INTERIM AMENDMENT

FEDERAL SPECIFICATION
TWEEZERS, CRAFTSMANS

This Interim Amendment was developed by the QM R&E Center (GL), Natick, Massachusetts, based on currently available technical information. This Interim Amendment has been approved by the Department of Defense and is mandatory for use by the Departments of the Army, the Navy and the Air Force. It is recommended that Federal Agencies use it in procurement. The General Services Administration has authorized the use of this Interim Amendment as a valid exception to Federal Specification GGG-T-870a, dated July 11, 1957, and Interim Amendment 1, dated June 6, 1961.

FIGURE 9A. *Type IX soldering tweezer.*

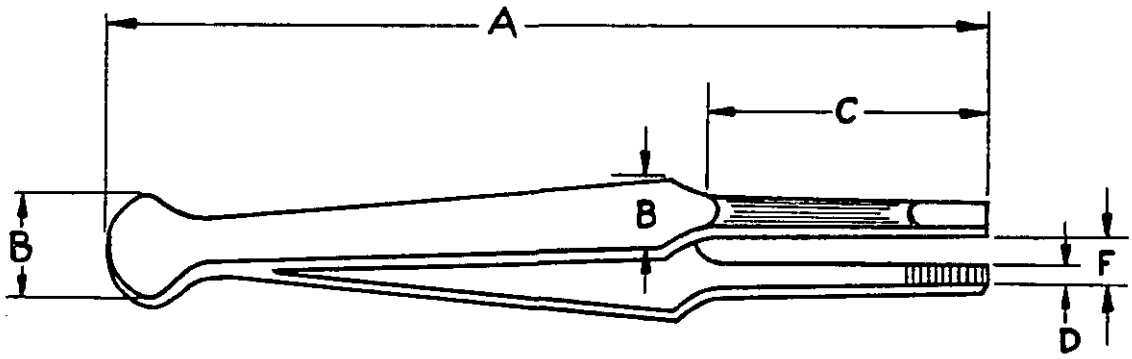
Page 6, paragraph 3.19—Renumber paragraph "3.19" to "3.20" and insert a new paragraph 3.19, table XA, and figure 9A, as follows:

"**3.19 Type IX soldering.** Tweezers shall conform to table XA and shall be similar to figure 9A. The inside surfaces of the jaws shall be serrated for a distance of at least 5/16-inch from the tip back towards the joint.

TABLE XA. *Type IX soldering tweezers*

Nominal size	Overall length A (±1/4)	Overall width B (Min)	Point length (C) Min	Tip width (D) ±1/32	Jaw opening (F) ±1/4
Inches 5	*Inches* 5	*Inches* 3/16	*Inches* 1 1/2	*Inches* 5/16	*Inches* 1/4
